METROPOLITAN GOVERNMENT OF NASHVILLE AND DAVIDSON COUNTY

STAFF RECOMMENDATION 110 Second Avenue North September 16, 2015

Application: New construction-rooftop addition, Signage, Alteration-window replacement

District: Second Avenue Historic Preservation District

1 1ST AVE WINDOW

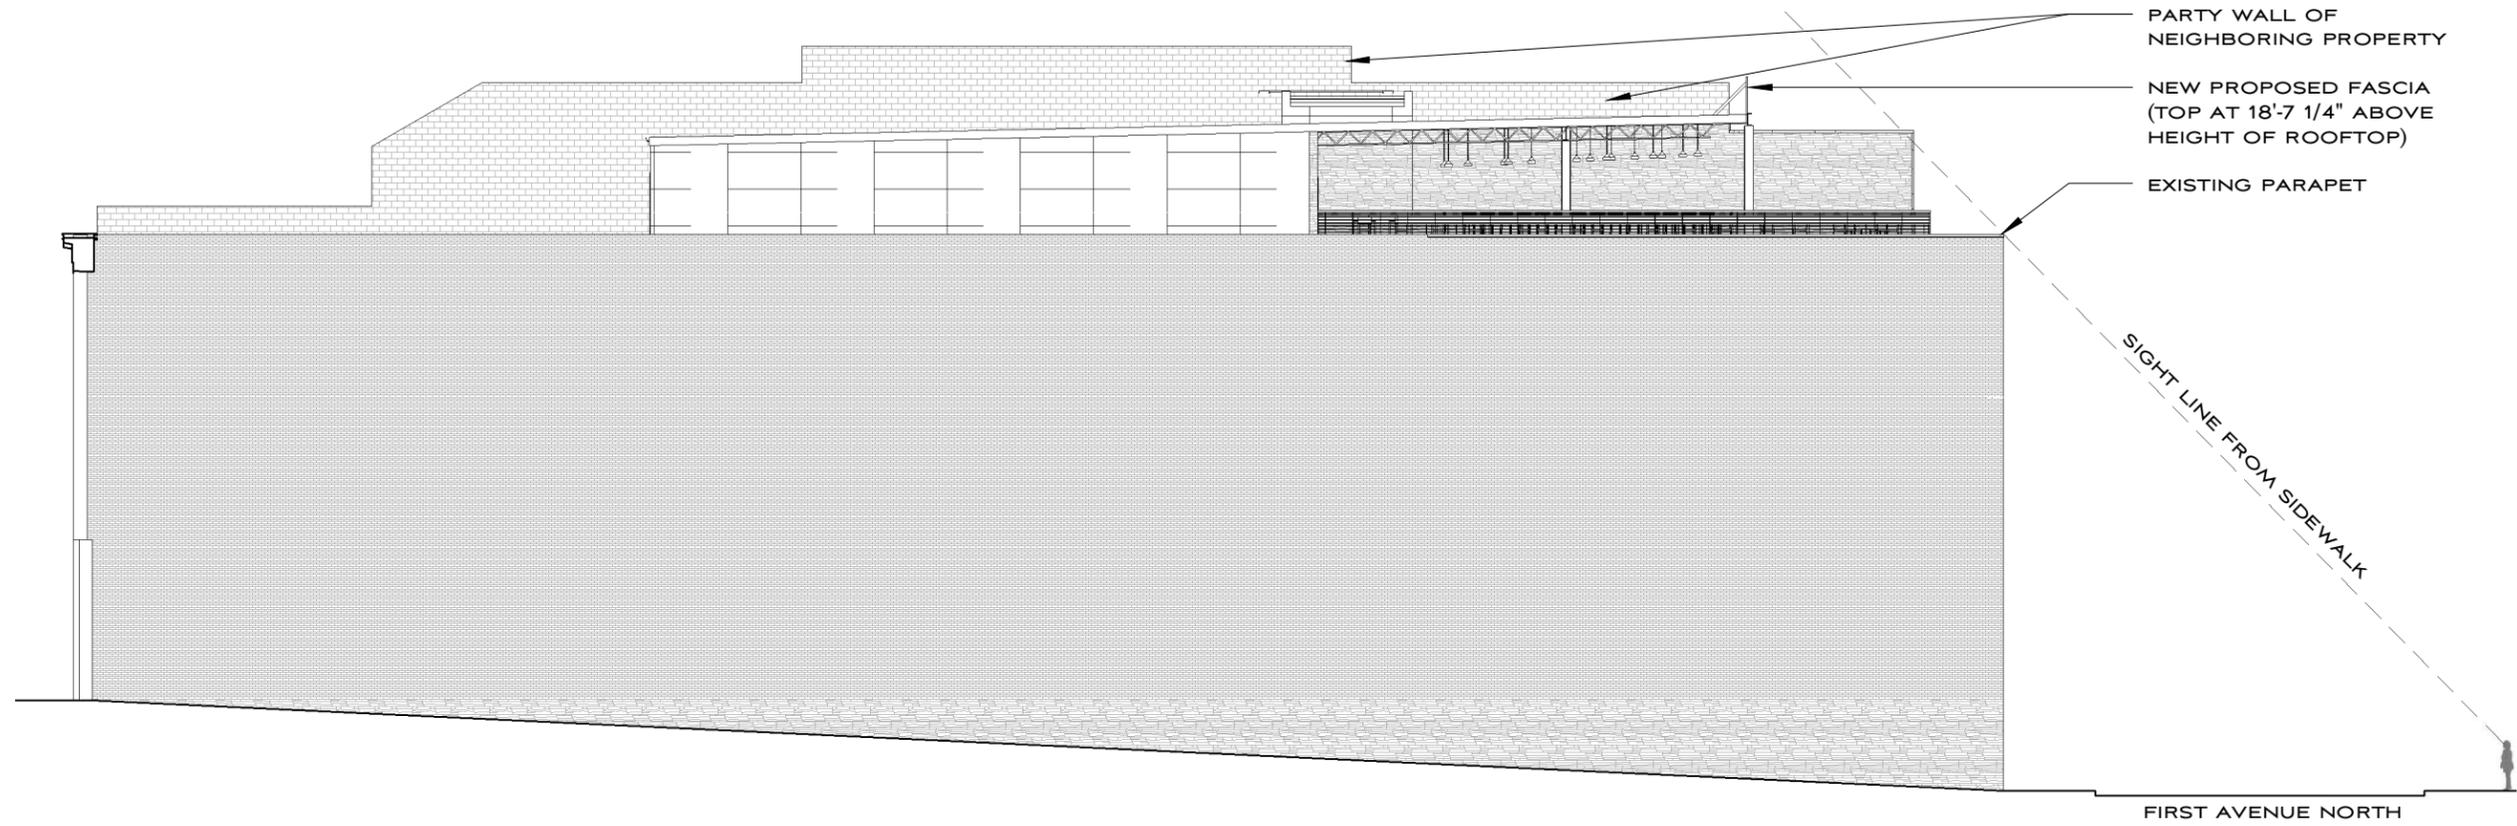
Staff has analyzed the existing window and finds that although it could be repaired, replacement is also a reasonable treatment option, due to its poor condition. The applicant proposes a fixed window along the bottom with $\frac{3}{4}$ of the upper portion of the opening being a rollup door. Because the floor will be raised on the interior, the bottom $\frac{1}{4}$ of the opening will be obscured glass. The applicant did not specify how that will be accomplished.

The Commission has not approved rollup doors on upper facades or primary facades in the past, finding that they do not meet the design guidelines that require that replacement windows “should replicate originals” and that “steel windows should be replaced with steel or aluminum designs that replicate the appearance of the original window” and because rollup doors are not found on upper levels or primary facades historically.

The industrial steel windows were a common alteration of the First Avenue side of this block and have become historic in their own right. A window with a fixed window in a portion of the opening with obscured glass and a roll up door is not a design that replicates the original. The Staff recommends disapproval since the proposed window does not match the historic windows and therefore does not meet section II.H.3 for window replacement or section II for rehabilitation: upper facades, general principles.

Staff recommends disapproval of the replacement of the historic industrial window with a roll-up door finding the project does not meet section II.H.3 for window replacement nor section II for rehabilitation: upper facades, general principles.

ALMOST FAMOUS
2ND AVE. PROJECTING SIGN

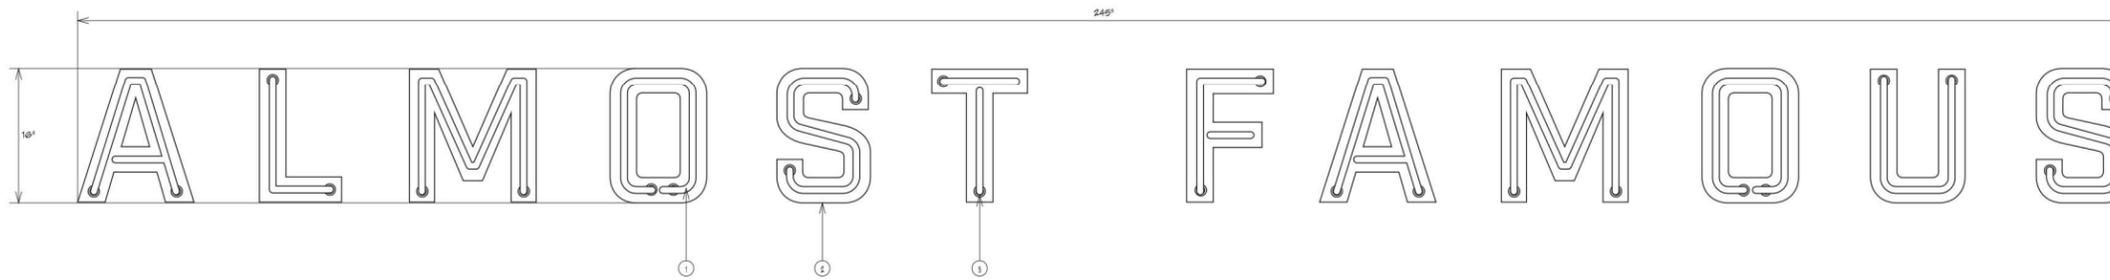
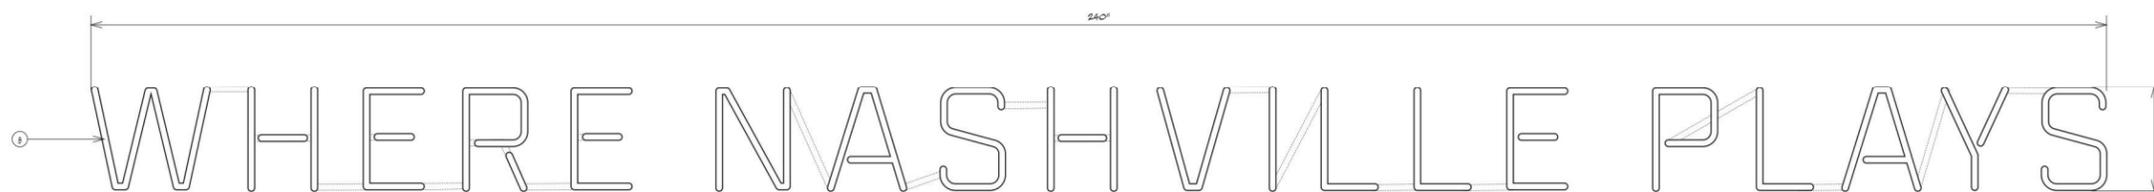
There is one projecting sign proposed for the Second Avenue side where the allotment is fifty-three square feet (53 sq ft). The proposal is for a twenty square foot (20 sq. ft) neon sign. The applicant claims that the proposal meets the requirement that it be at least twenty-five feet (25’) from any other projecting signs. The sign does not obscure architectural details and is located in an appropriate location. The design guidelines require that the sign have a minimal of spacing from the building of twelve inches (12”) and not project more than a total of six feet (6’). The proposal meets those specifications. The depth of the cabinet meets the maximum of eighteen inches (18”) and the height of the sign does not exceed the maximum.

The project includes bare bulbs along two sides of the sign; however, this is a “prohibited” light source according to the design guidelines. Staff recommends that the bare bulbs be removed from the design.

- The top proposed sign of the First Avenue side be removed because it exceeds the allotment for signage, is located in an inappropriate location, and causes the addition to exceed the height maximum;
- Signage not include bare bulbs;
- The railing on the First Avenue side not be used to support additional elements such as speakers, lighting, plants or signage;
- Staff approved dimensions and locations of speakers; and,
- Staff review final masonry prior to purchase and installation.
